Assessment of Twenty-Eight (28) Trees  
At Sunrise Senior Living Facility, Redwood City (Proposed)  
(Multiple Residential and Commercial Lots)  
2915 El Camino Real  
Redwood City, California

Revised 10/25/2017

iii. Storm Drain Pipe Trenching / Shallow Cut Protocol:

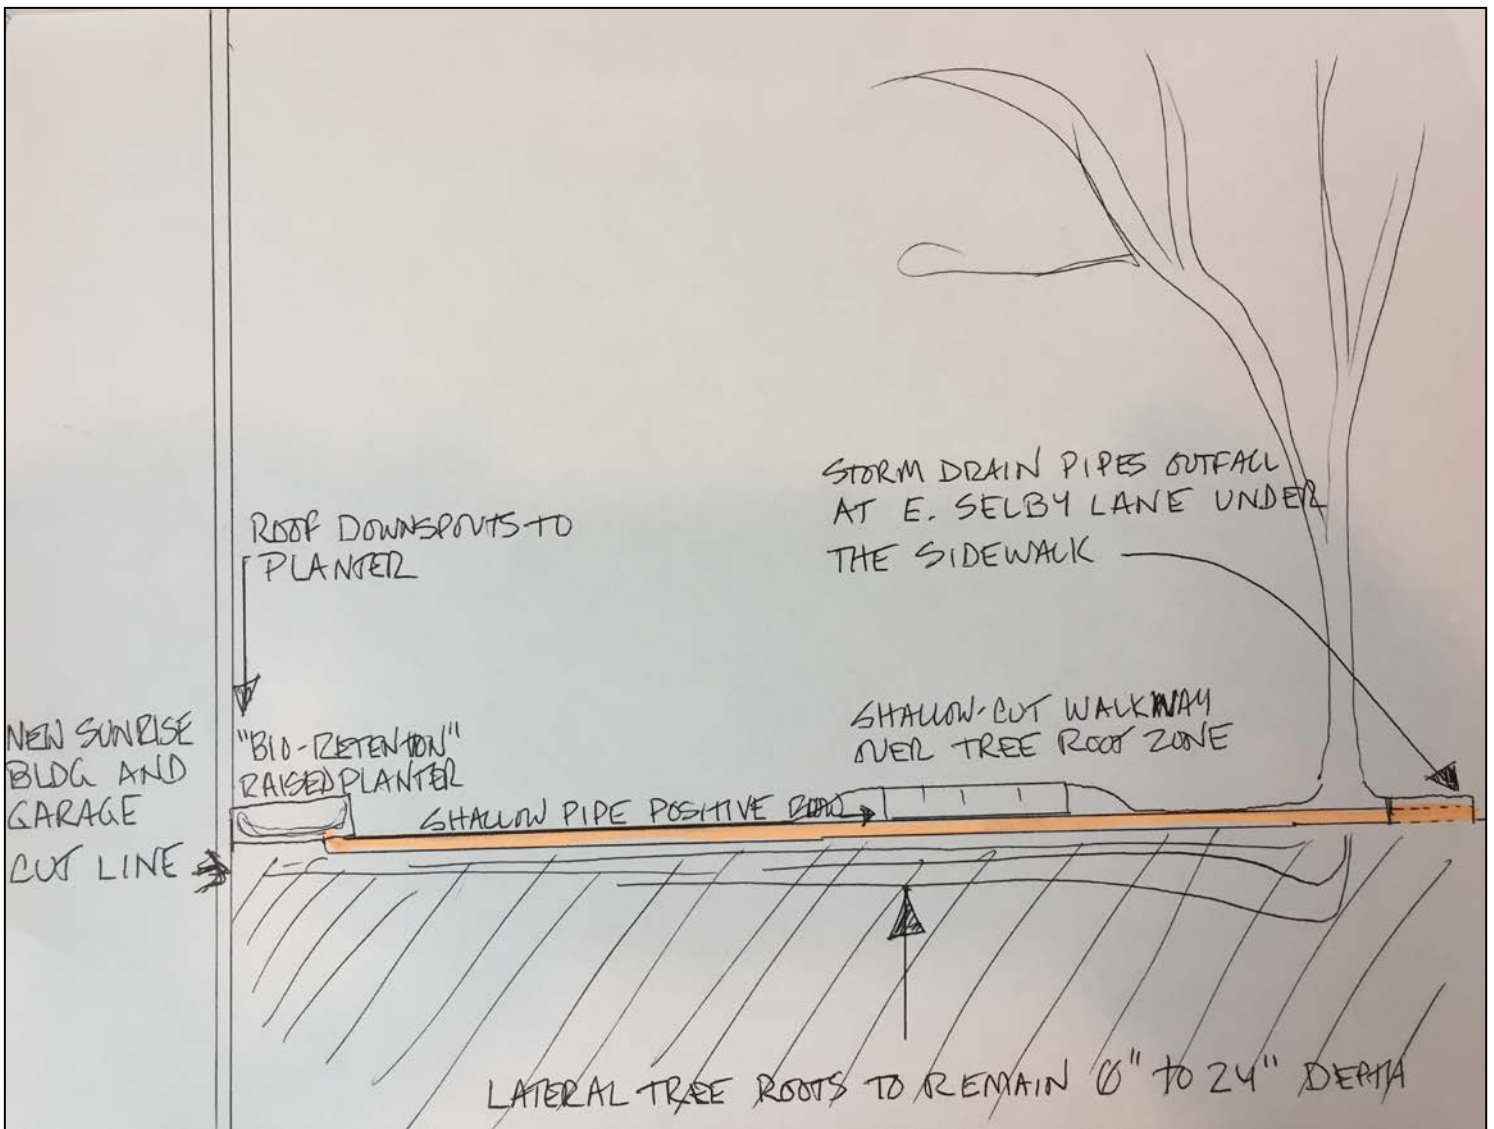
It is suggested that the project team shallow-cut all proposed trench routes for all utilities and drainage pipe alignments (including landscape plant and tree irrigation pipes) which are proposed for the areas within 15 linear feet of trees being retained. Per WLCA's markup below, and per WLCA's discussion with the project civil engineer Kier and Wright<sup>1</sup>, the new storm drain pipes will run from over-grade generally eastward toward E. Selby Lane, as very shallow cut trenches at or slightly below existing soil grade (i.e. soil grade elevations after existing older asphalt and baserock parking lot materials roughly 4 inches thickness or more are removed from the site). The storm drains are to run through the existing sidewalk slabs, and outfall onto the roadway surface at E. Selby Lane.

If possible, the actual storm drain pipe cut depth should be no deeper than 1 to 2 inches below soil grade, through the zone between the raised bed bio-retention planters and E. Selby Lane. See the WLCA side cut detail sketch below on page 13 (conceptual only, not to scale), showing how the shallow-cut storm drain pipe system would be installed with relatively very little loss of lateral woody tree roots from **trees #1, 2, 3, 4, 6, 7, and #10**. In order for the system to work, the construction phase team will need to limit scarification of the existing parking lot area, removing only 4-inches of material from over the soil root zones of the trees, thereby preserving the lateral woody roots extended westward and southward from trees #1 through #12 along E. Selby Lane. The construction team will also need to ensure that all excavation for the new base rock base section of the walkway is actually at or above original soil grade so as to avoid destroying the root systems of trees #1 through #12 between the trunks of the trees shown at the right of the image, and the new Sunrise building and garage siding limit at the left side of the image:
